GRAND GULF NUCLEAR STATION
UNIT 1

RELIEF REQUEST I-00002, REVISION 3

INSERVICE INSPECTION
OF PRESSURE RETAINING WELD IN SCRAM DISCHARGE VOLUME PIPING

GRAND GULF NUCLEAR STATION
INSERVICE INSPECTION
TEN YEAR PROGRAM

FIGURE 19

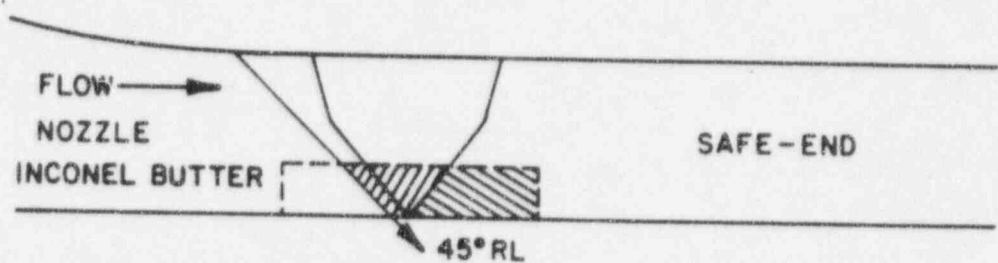
JET PUMP INSTRUMENTATION NOZZLE TO SAFE END WELD

Automated techniques provide a 45° shear wave examination from the safe end side, obtaining two-directional coverage of 0.10 in² or 34.5% of the total code volume.

FIGURE 1

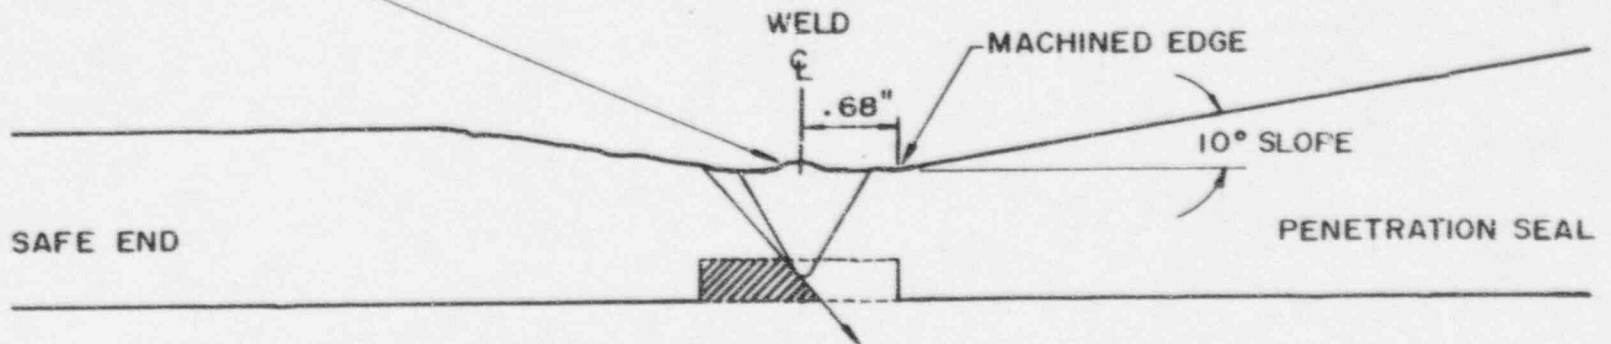
The weld is volumetrically examined from the safe end, obtaining 44.7% coverage of the code volume. Examination from the weld and from the penetration seal side of the weld is prohibited due to component configuration and weld geometry (see Figure 1).

-  CODE VOLUME FOR VOLUMETRIC EXAMINATION = $.228 \text{ IN}^2$
-  EXAMINABLE VOLUME FOR VOLUMETRIC EXAMINATION = $.102 \text{ IN}^2$ or 44.7%

FIGURE 2

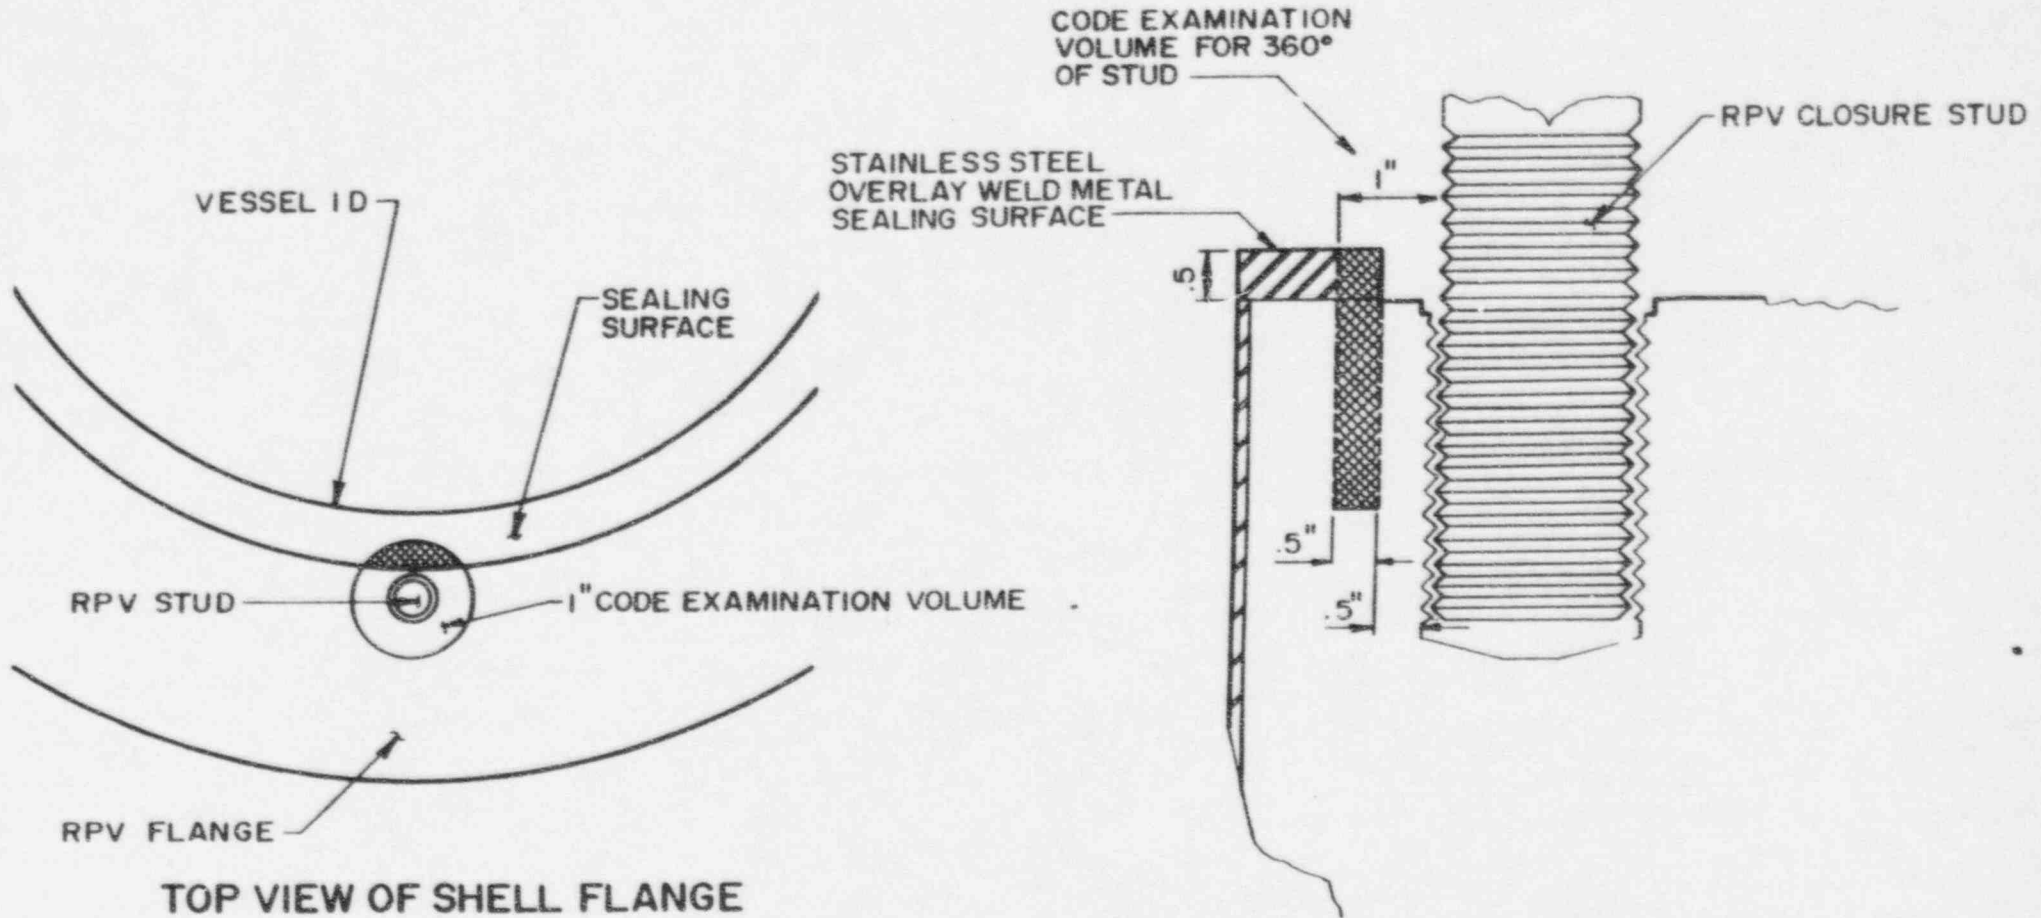
A code volume of 96% is volumetrically examined without interference with the seal surface. The remaining 4% is contained within the restricted area associated with the seal surface (see Figure 2).

UNABLE TO SCAN FULL 1" CIRCLE AROUND STUD HOLE
